CCMC Flood Control Project Steering Committee

The **CCMC Flood Control Project Steering Committee** met Monday, November 9, 2020, at 3:00 p.m. meeting took place over zoom. Present were Committee Members Floodplain Administrator (FPA) Samantha Malenovsky, City Councilperson (CCP) Austin Lott, Custer County Commissioner (CC) Jason Strouf, Public Works Director (PWD) Scott Gray, Grant Writer Ally Capps, (KLJ) Carl Jackson, and (KLJ) Becky Bey.

MILES CITY SECTION 205 FEASIBILITY STUDY
TONGUE AND YELLOWSTONE RIVERS
MILES CITY, MONTANA

Miles City Flood Control Study Minutes
October 26, 2020

Figure 16

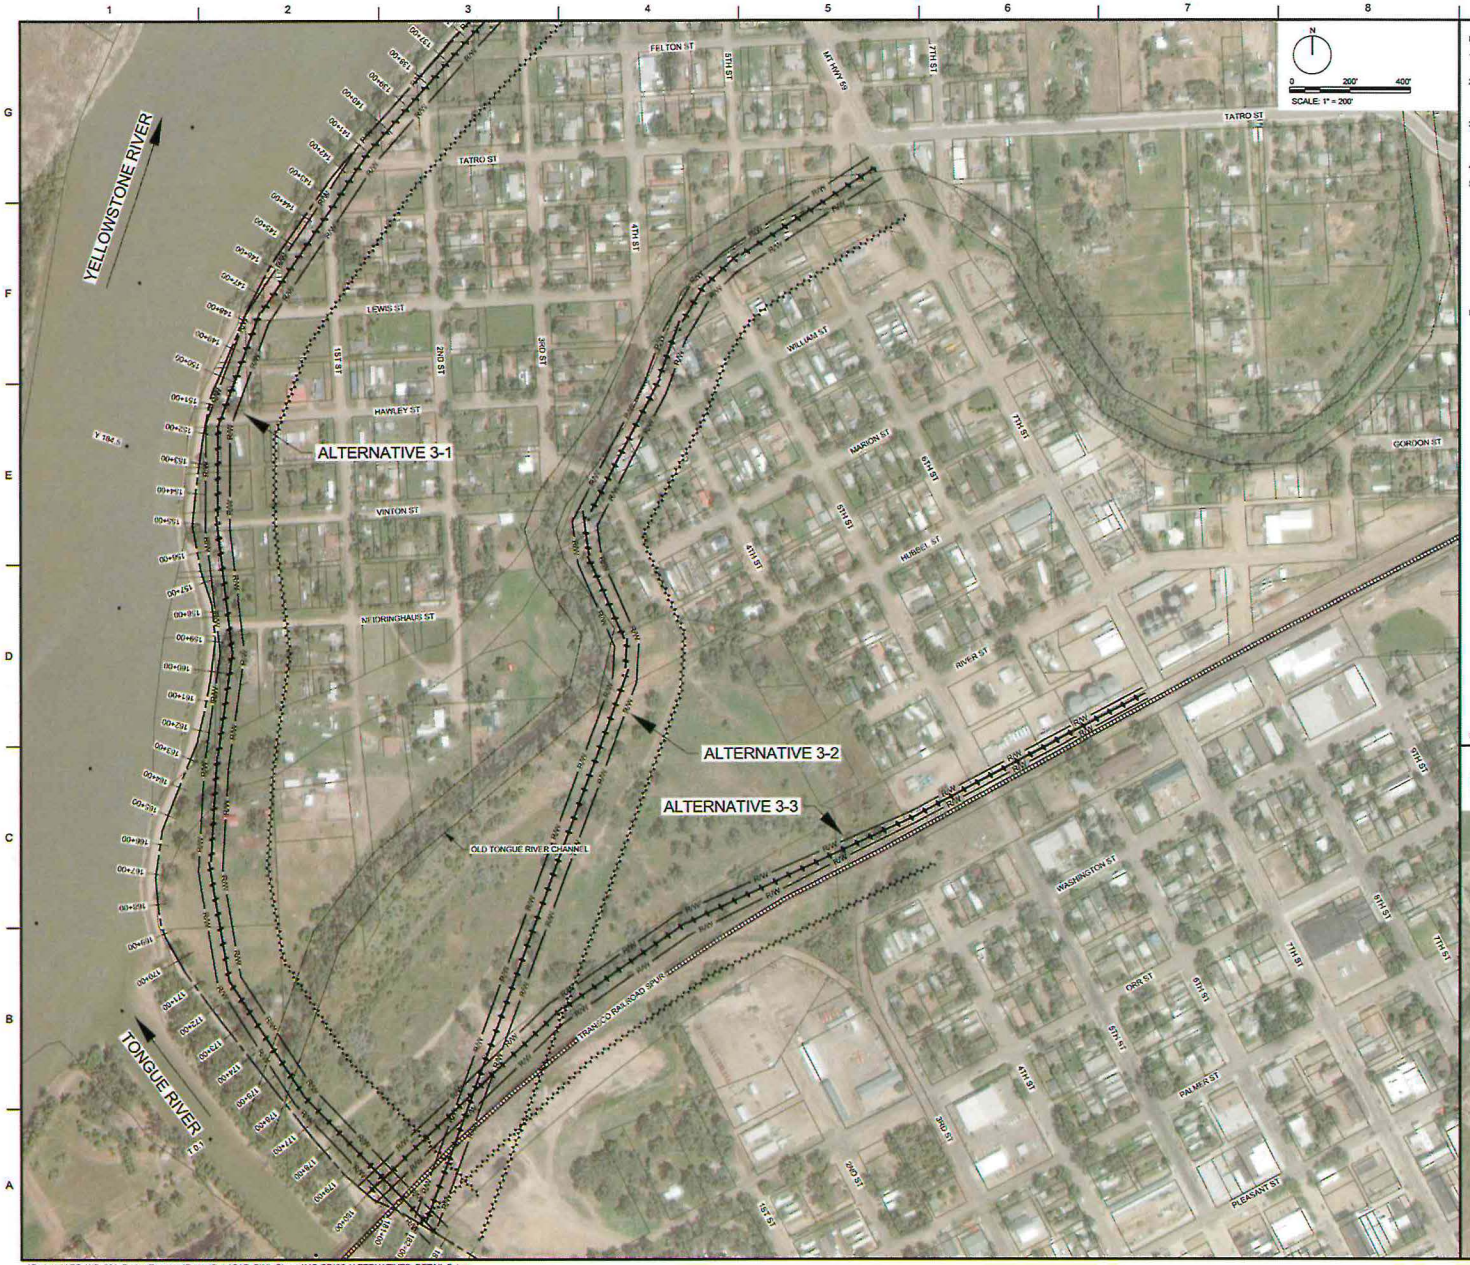
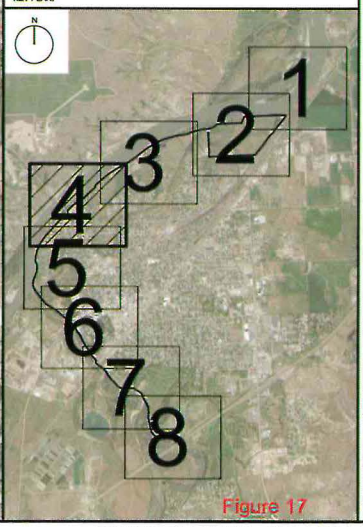
Figure 16, 17 shows Reach 3 and the alternatives contacted within. Alternative 3-1 is the costliest of the three alternatives due to the amount of riprap required. The cost of alternatives 3-2 and 3-3 do not include the cost of real estate and relocating property owners. Figures 20-22 is an inundation map with the three alternatives in reach 3. All alternatives stop at Highway 59 since this is how far the USACE think the Section 205 grant money could go and is the best location to tie off the levee. The rest of the levee (to the wastewater treatment plant) would be something that would be up to the community to complete. PWD Gray pointed out that whichever alternative the community chose under the Section 205 project would probably set up the future alignment of the levee to completion. Alternative 3-2 would probably need a trailing levee that could extend to the southeast along the west side of Highway 59N to prevent backwater.

Figure 18
CONCEPTUAL PLANS - NOT FOR CONSTRUCTION

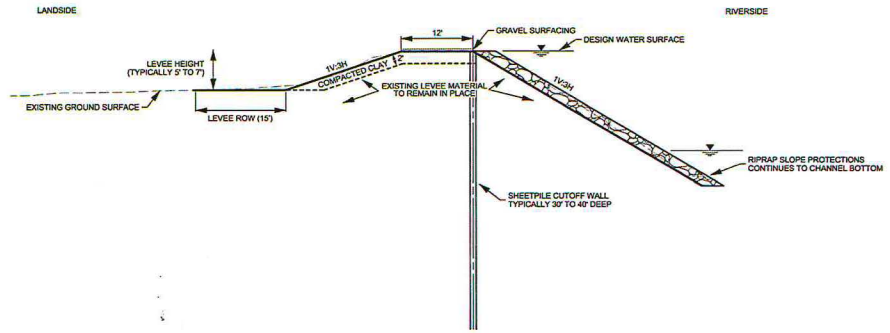
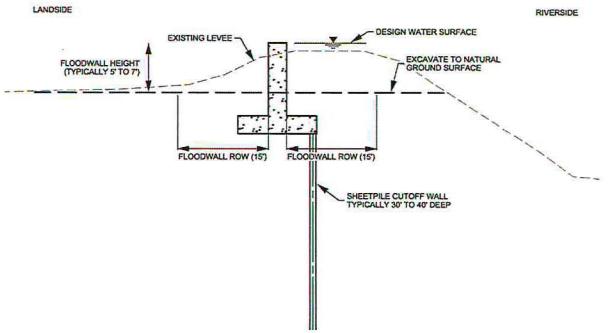
Figure 18 shows potential levees that could be used in combination with each other. Figure 18, Figure F1 is a levee design that requires minimal maintenance, is the least expensive overall and the safest but requires the largest amount of real estate. Figure D1 is the toe drain which would require more maintenance, the toe drain would require a lift station to pump the excess water over to the river, the property required would be less. Figure B1 with sheet pile cutoff wall is the most expensive of the three and a flood wall would require the lease amount of property with the most upfront cost. These options could be used in conjunction with each other depending on the need of the surrounding areas.

Figure 21

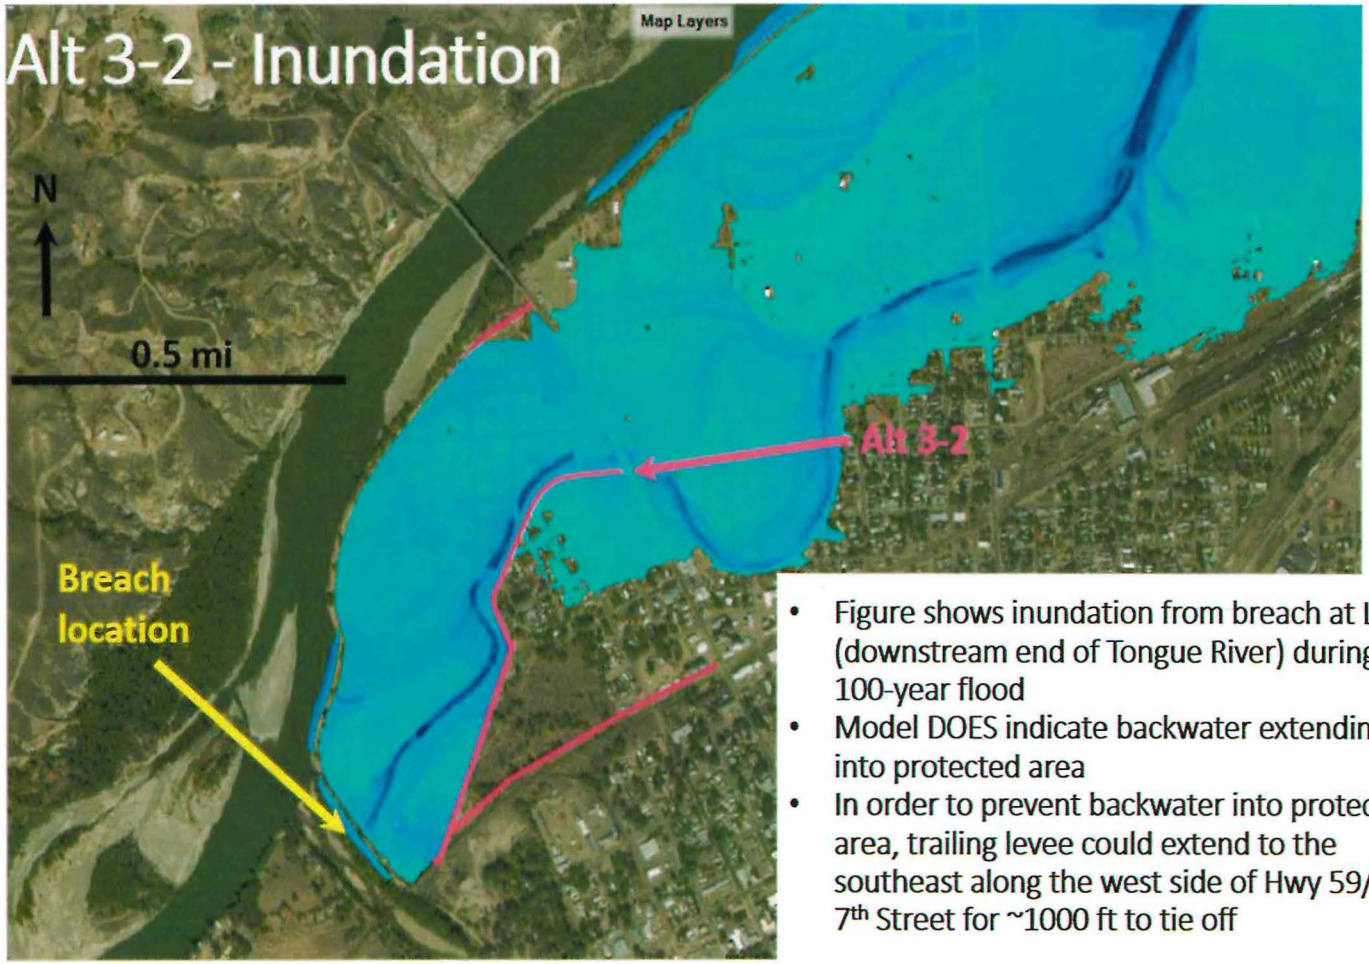
Alternative 3-2 crosses the wilderness area then moves along the south side of the slough to N. Seventh. This alternative would leave a large portion of properties unprotected in a flood event. The inundation map, figure 21, shows that the entire area north of the slough would be inundated along with a portion to the south west of the intersection of the slough with N. Seventh. To address this issue some sort of closures could be placed to deflect the backwater.
